M.V. "ROSE-JULIE M."

DIMS 140'-0 B? × 26'-0" × 11'-0" MLD.

DRAWING N°3881

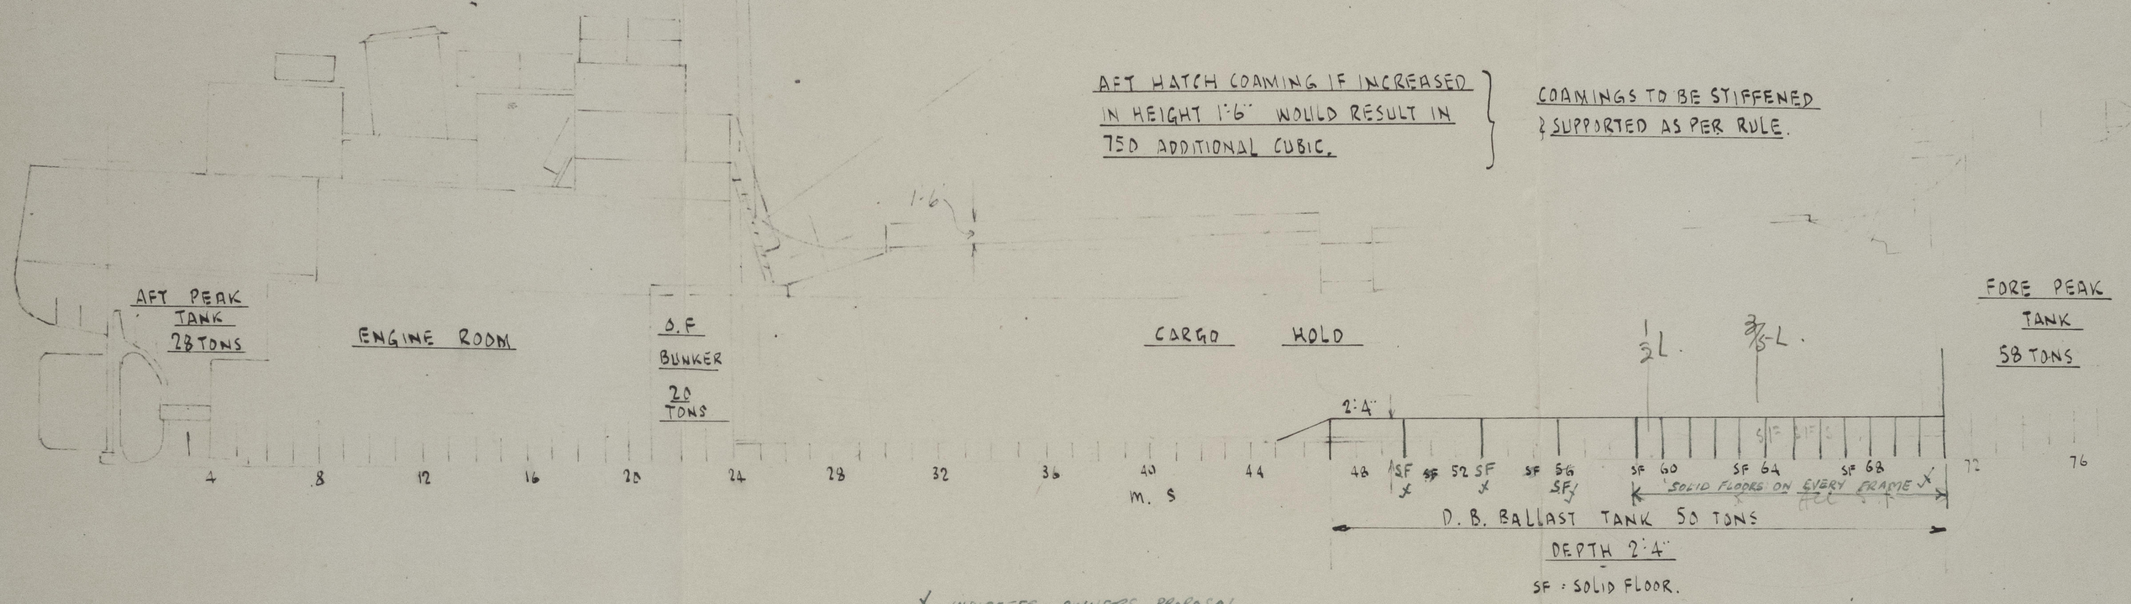
AFT HATCH COAMING IF INCREASED IN HEIGHT 1'6" WOULD RESULT IN 75D ADDITIONAL CUBIC.

COAMINGS TO BE STIFFENED & SUPPORTED AS PER RULE.

INDICATES OWNERS PROPOSAL SEE LETTER DATED 26/7/48.

SECTION XX

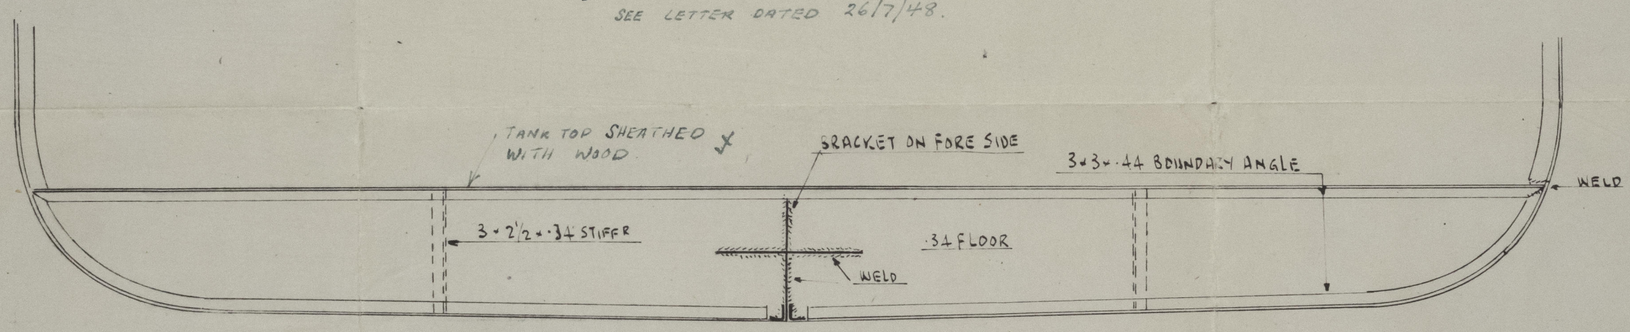
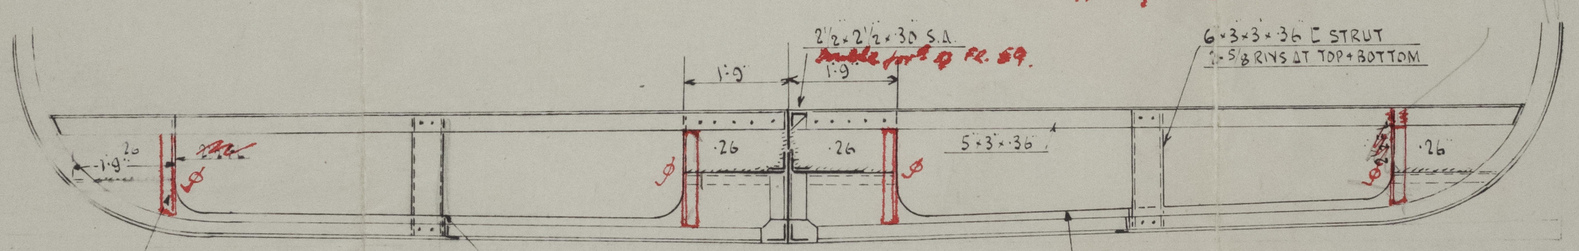
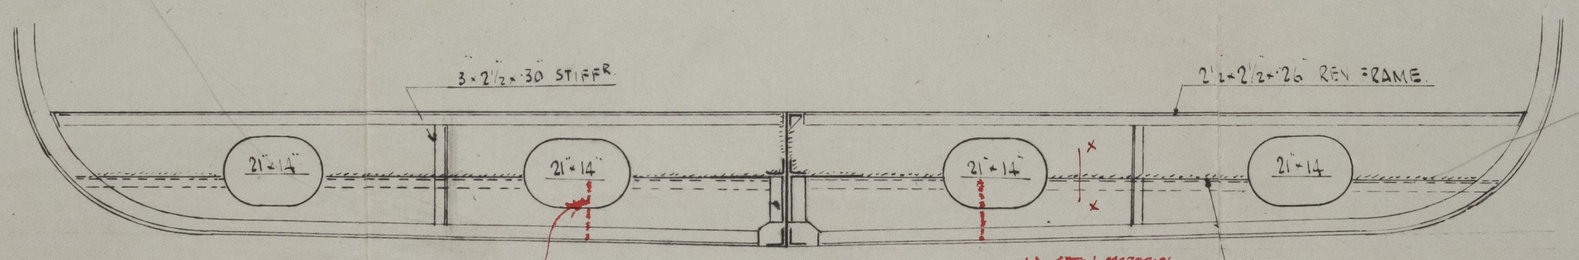
LEAVE EXISTING FLOOR & REVERSE BAR AT ENDS & CENTRE THUS

CROP EXISTING SIDE KEELSON BACK TO 5" FROM HEEL OF BAR

CROP EXISTING FLOORS BACK TO 5" FROM HEEL OF FRAME.

½ Right intercostal between frs 60 and 71. Manhole repositioned to suit. (corresponding to position of existing keelson.)

WELD NEW TOP PIECE TO EXISTING FLOOR.
